December 12, 2001

### **SUBJECT: EVALUATION AND REPORTING ON CONTAMINANT HYDROGEOLOGICAL CONDITIONS AT THE TAJIGUAS LANDFILL**

**EVALUATION OF THE  
DRAFT EIR  
AND SELECTED REGULATORY CASE FILE  
TECHNICAL REPORTS  
ASSOCIATED WITH THE  
TAJIGUAS SANITARY LANDFILL**

# Original Topography of Vicinity of Pila Creek

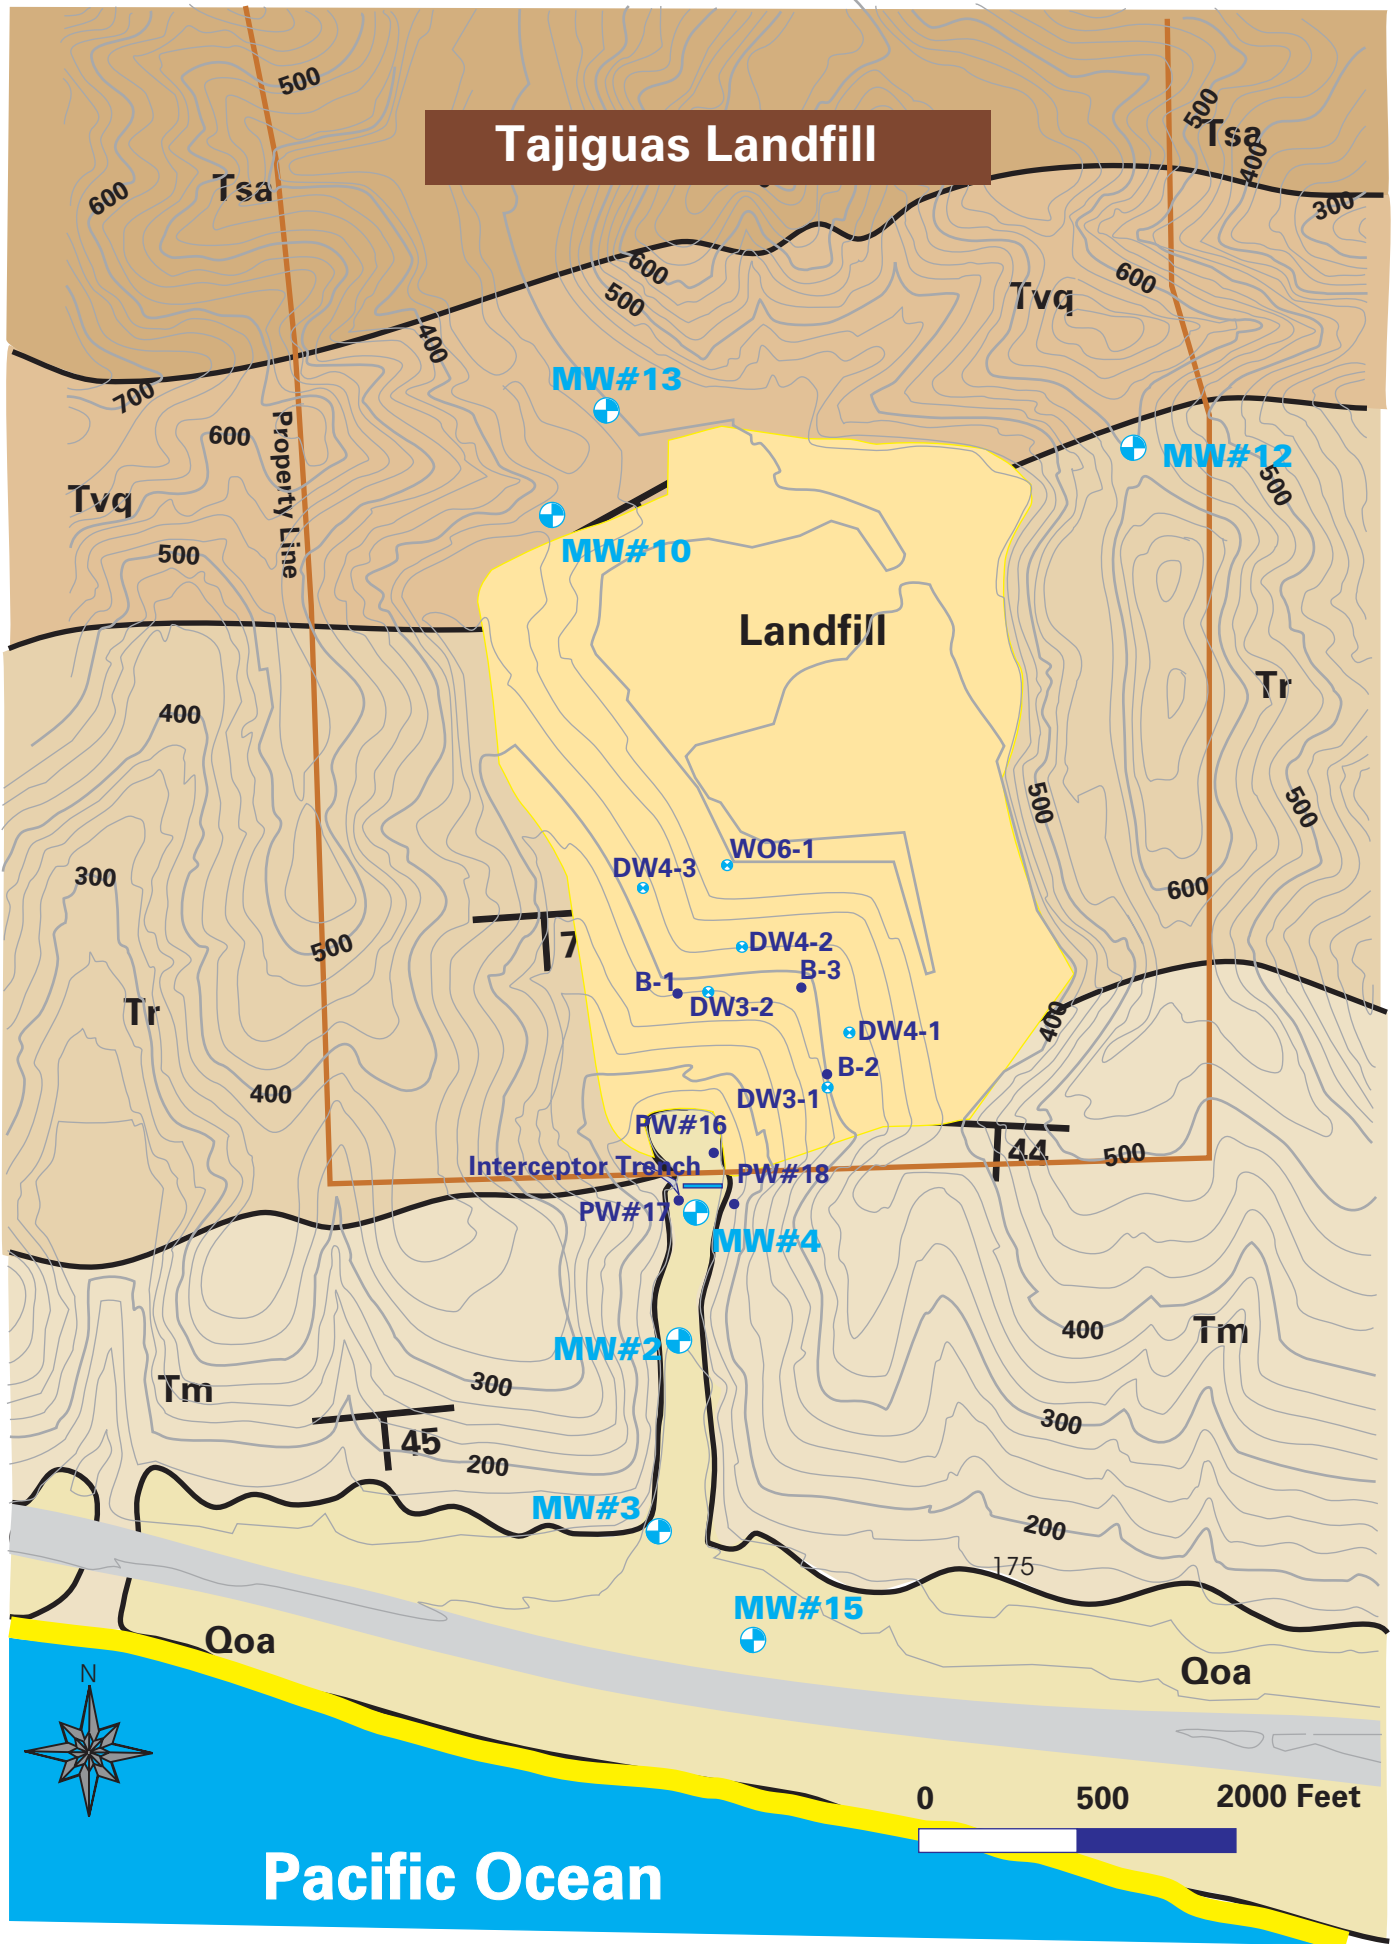
enough or **as underflow** in alluvial fill or **fractured bedrock below the channel.**” It is clear that intensely fractured rock likely exists in bedrock below the channel and can be very permeable allowing contaminated underflow to bypass the interceptor trench. The original topography and Pila Creek bed are shown on GeoSolv **Original Topography of Vicinity of Pila Creek** map.

- 1) Define the contacts between the existing landfill mass and all man-made conduits, all discernable artificial fill, disturbed soils, and formations through field subsurface investigation. This will reveal conduits for the migration of landfill contaminants to surface water and groundwater. All subsurface investigation should be conducted through a conductor casing. A structure contor map of the bottom of the landfill relative to GW table contout map should be produced to provide crossesection of the bottom of the landfill relative to the water table. Enegeneering designs must be developed and implemented for the purpose of

preventing the high water table from intersecting the landfill mass.

# Cross Section A-A'

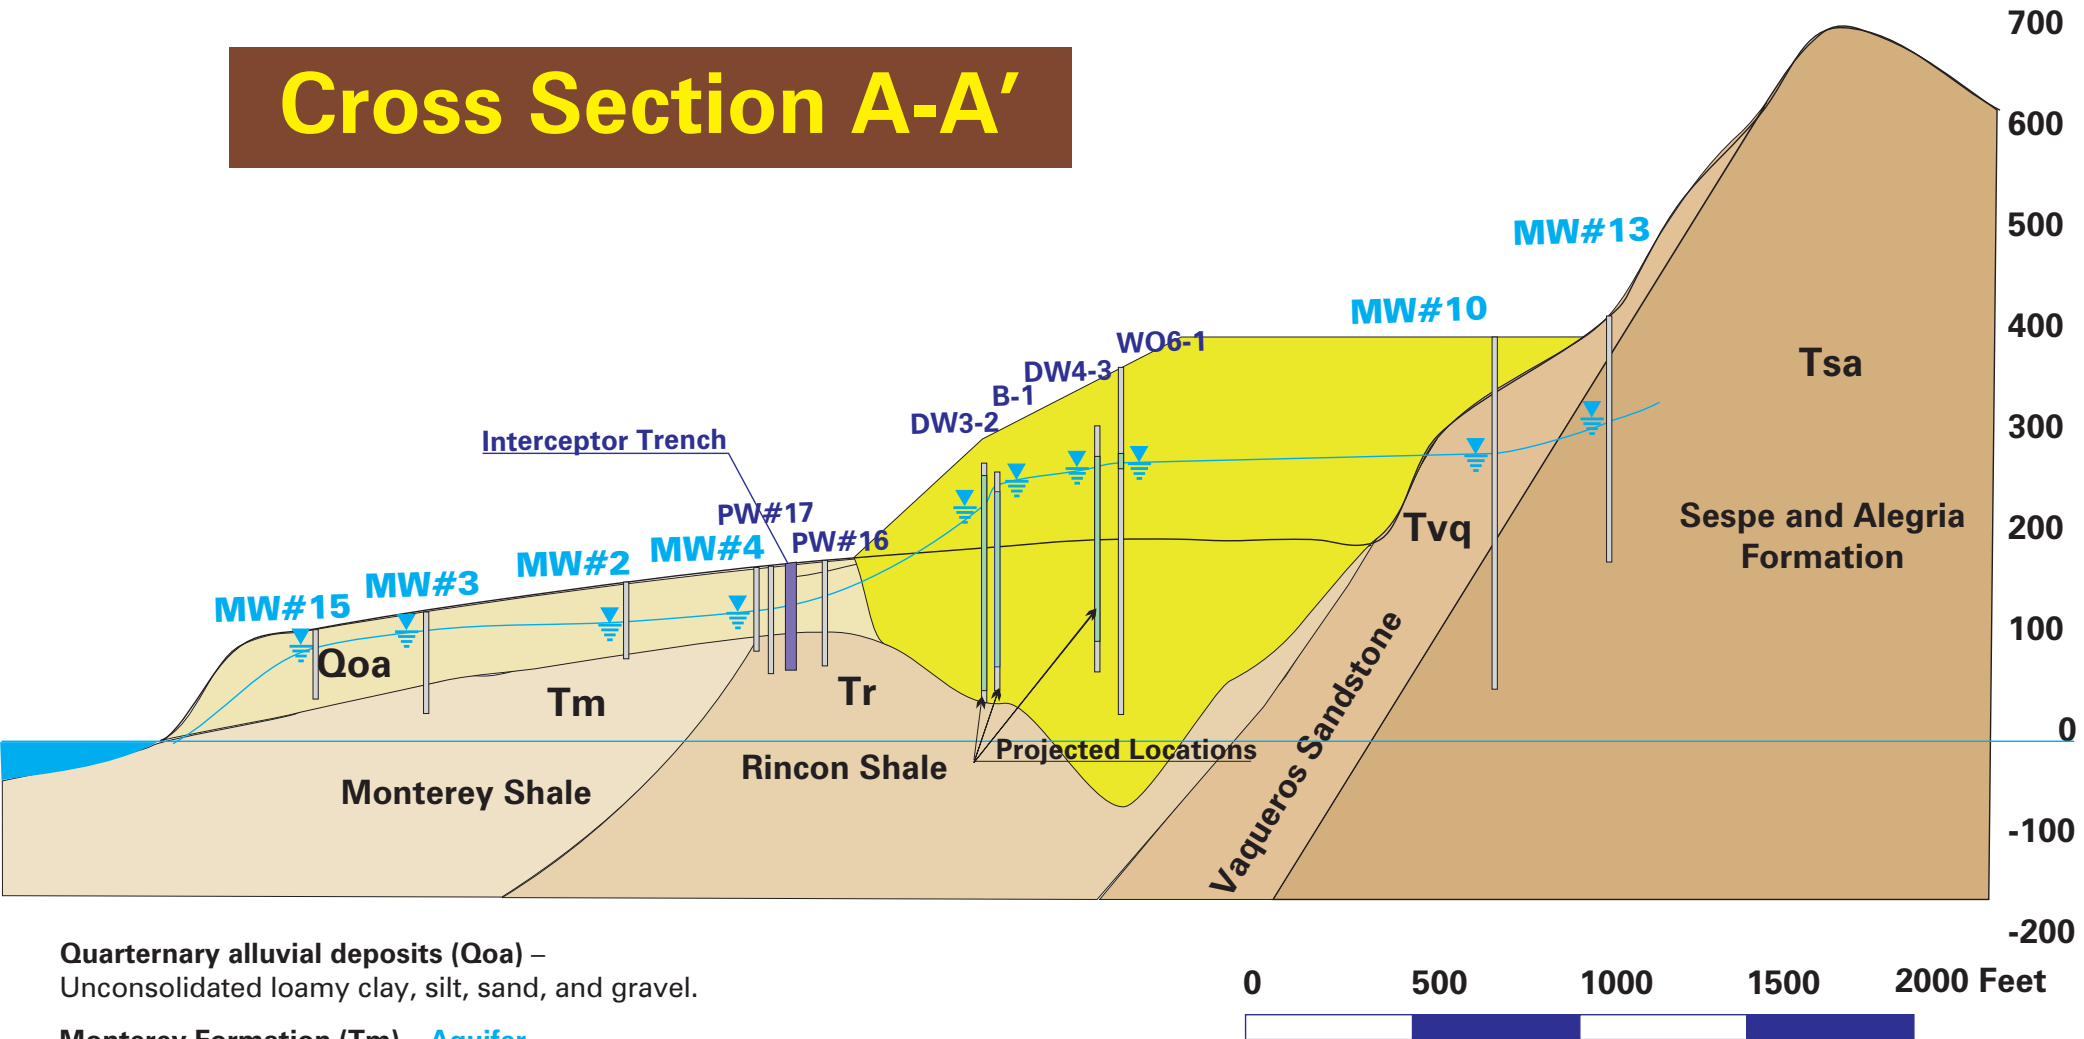
A review of the Collection Trench Profile and Details in the June 17, 1998 Corrective Action plan shows that the original trench excavation was founded in at least eight (8) feet of unweathered Rincon to intercept some of the underflow of groundwater contaminated by the landfill from exiting the confines of the landfill and migrating offsite to the beaches and ocean. Although, this implies that the unweathered Rincon is impermeable, the Environmental Impact Report, TABLE 3.2-3 STRATIGRAPHY OF TAJIGUAS LANDFILL PROJECT SITE) states that the **“The unweathered Rincon is mainly massive, but zones of intensely fractured rock have been observed.”** The Environmental Impact Report, page 3.3-9 states, **“The groundwater flows** from topographically high areas downward to stream channels, **where the flow emerges** as discharge to the streams if the water level is high

The Collection Trench Profile and Details cross section also verifies that the 20 to 35 feet of soil exposures on the east and west sides of the trench are permeable alluvium. (**See GeoSolv Tajiguas Landfill Map**) This provides migratory pathways for contaminated groundwater to bypass the trench and contaminate groundwater in the Monterey Shale formation, at the Arroyo Quemada community and the beaches beyond.

On page 3.3-17 of the Draft EIR the Monterey Formation is stated to consist of “weathered and fractured Monterey Formation shales and siltstones south of the existing landfill, as well as valley bottom alluvial and colluvial deposits in the lower canyon area.” Since the monitoring wells, located down gradient of the interceptor trench, are founded in colluvium, contaminated groundwater underflow in the fractured shales and siltstone may escape the grossly inadequate monitoring system and reach the beach and ocean.
